October 7, 1986

Mr. Michael J. Sanderson
Chief, RCRA Branch
Waste Management Division
U.S. EPA Region VII
726 Minnesota Avenue
Kansas City, KS 66101

This letter is sent on behalf of our client, The Maytag Company, in response to your August 8, 1986 comment letter regarding the April 1985 Closure Plan. Responses to your comments use the same numerical designation as delineated in the August 8, 1986 letter. Once the responses have been approved, they will be incorporated within the Closure Plan to provide a complete, self-supporting document.

SEP 1986
FIGURE 1A

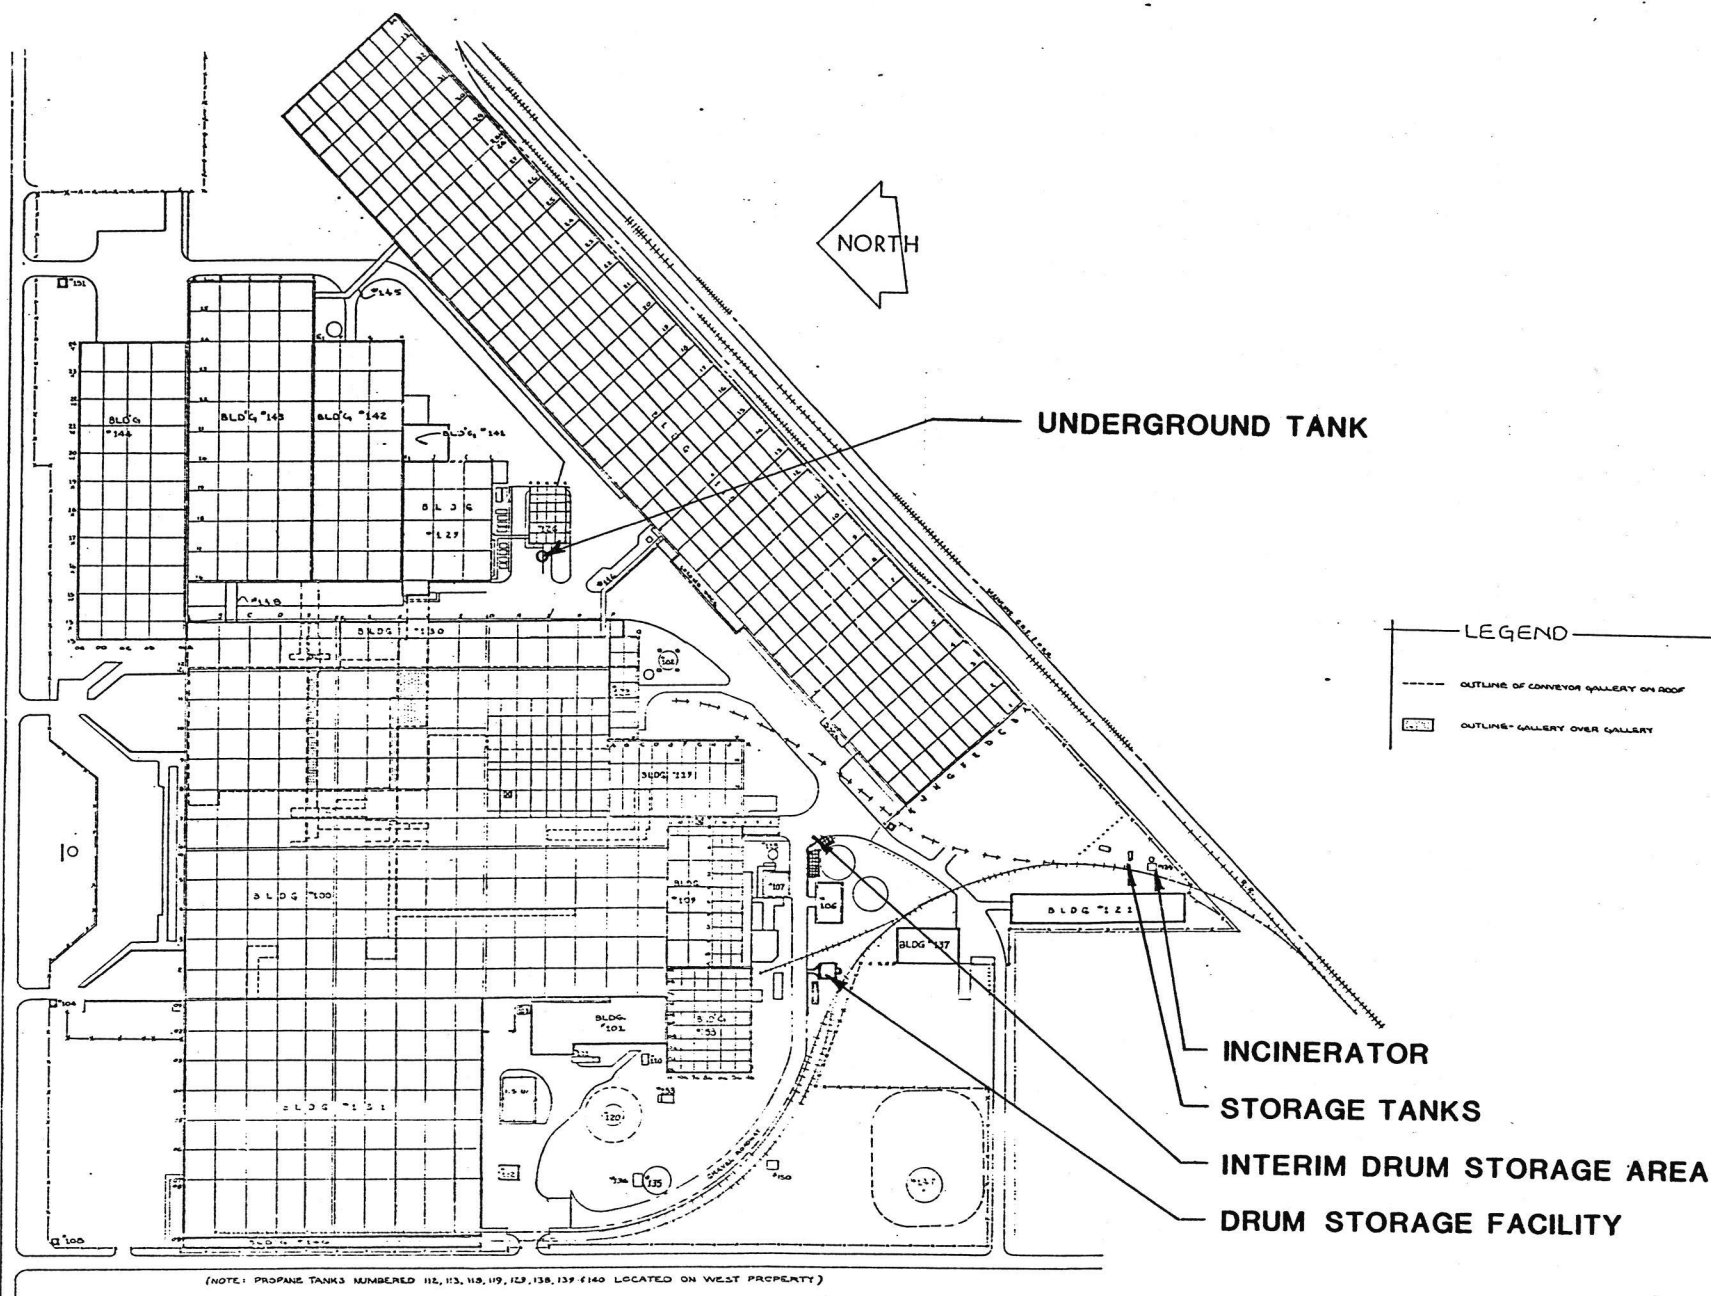
3. An additional Figure, 1A, has been added to indicate the location of all of the areas subject to RCRA closure. Figure 1A should only be used to determine the relative locations of the hazardous waste management units. Specific details and information for each unit is contained on the existing figures and in the text.

Since the initial Closure Plan was prepared, Maytag has identified a 400 gallon, mild steel, asphaltic coated, underground tank that was used to collect flush waste solvent prior to transport to the four incinerator storage tanks. There is no evidence of tank leakage. The tank was also taken out of service on or about August 1984. The tank and surrounding soils will be sampled and excavated as necessary to the cleanup levels proposed in Table 9. The location of the underground tank is identified in Figure 1A.

14. The only areas used to store hazardous waste in excess of 90 days were the drum storage pad, the storage tanks and the interim storage pad next to the treatment plant (see Figure 1A).
